TECHNICAL SERVICE BULLETIN

2021-2022 Bronco - Whistle Noise From Left Exterior Mirror

22-2297

21 July 2022

Figure 1 - Left side shown, right side similar

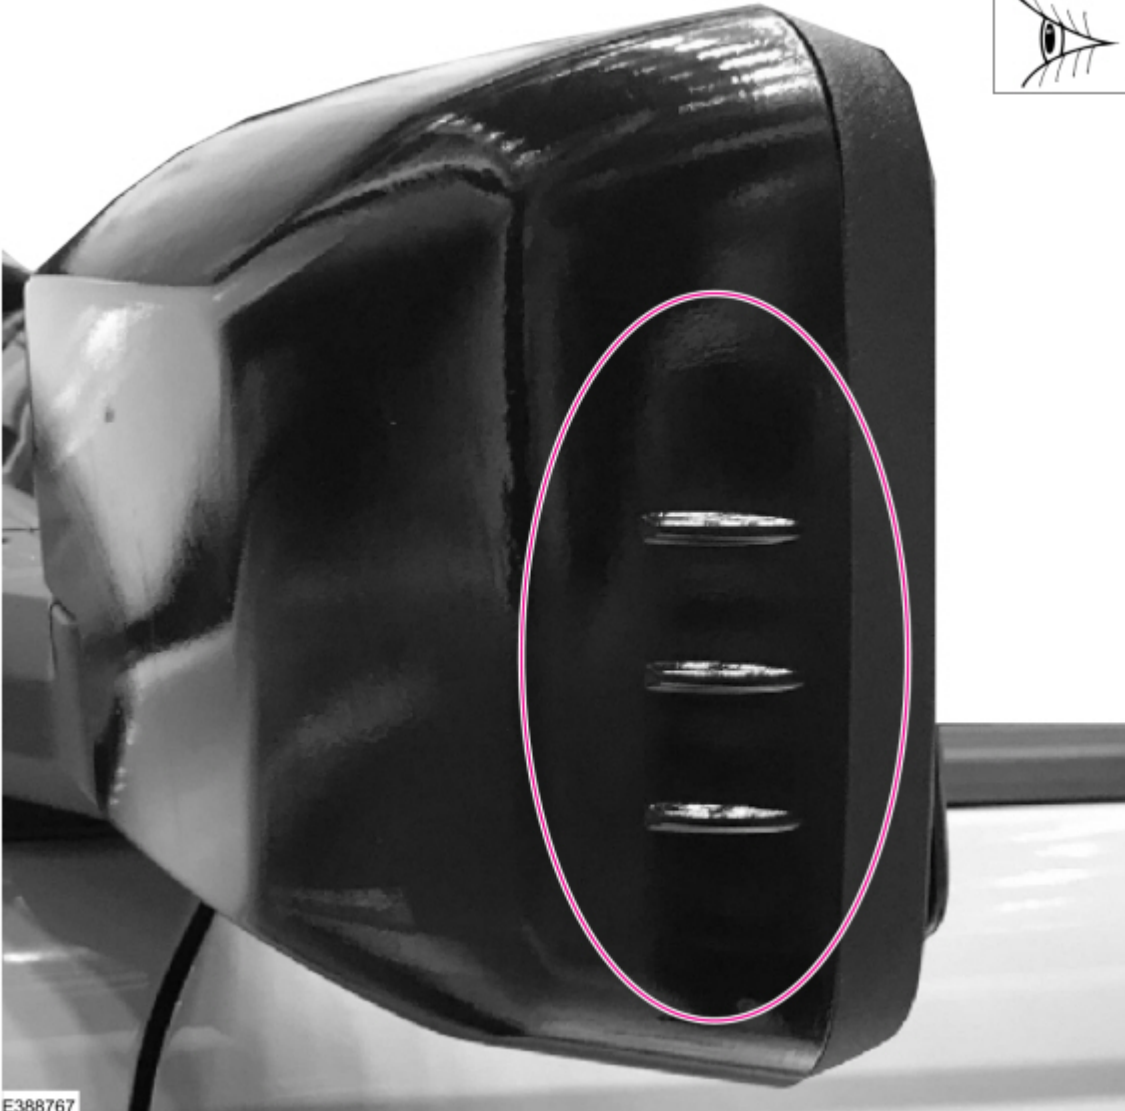
Issue: Some 2021-2022 Bronco vehicles equipped with base exterior mirrors (does not have integrated puddle lamps and/or turn signal lamps) may have a whistle noise that originates from the left exterior mirror. This may be due to the design of the exterior mirror cover. To correct this condition, follow the Service Procedure to replace both the left and right exterior mirror covers.

1. Does the left exterior mirror have 3 horizontal fins on the outboard side of the mirror cover? (Figure 1)

- (1). Yes - this article does not apply. Refer to Workshop Manual (WSM), Section 100-04 and continue with normal diagnostics.
- (2). No - replace both the left and right exterior mirror covers. Refer to WSM, Section 501-09. Both the left and right exterior mirror covers must be replaced to maintain a consistent vehicle appearance.
